R09PL

**SUBJECT: RECALL R09PL REAR HEADLINER FMVSS JOINT
STRENGTH NONCOMPLIANCE**

Headlining Rivets

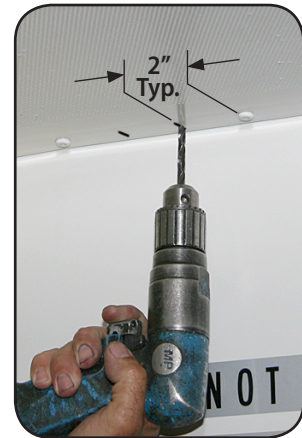
On some units, the rivet spacing may be incorrect in some segments of the rear headlining and rear upper inner panel joint, resulting in noncompliance with FMVSS 221, School Bus Body Joint Strength.

- 1** Park vehicle on level surface, apply parking brake, remove ignition key and chock wheels.
- 2** Inspect rivet spacing at rear headlining and rear upper inner panel joint. Joint must have a minimum of four rivets in an eight inch segment.
 - 2.1 Place the template over the joint and parallel to the edge of the headlining panel, allowing roof rivets to be exposed through the opening in the template as shown.

- 2.2 Move the template from one side of the headlining panel to the opposite side.
- 2.3 If a segment in the rear headlining panel joint contains less than four rivets, additional rivets are required. Mark each area that requires additional rivets. Rivets should be spaced on approx. 2" centers.
- 2.4 If additional rivets are required; add additional rivets between the largest spaces until a minimum of four (4) rivets have been added in the 8 inch segment.

- 3** Using a short 7/32" drill bit, drill a hole through the headlining panel and the rear upper inner panel. Be sure to drill hole on a common center-line with existing rivets.
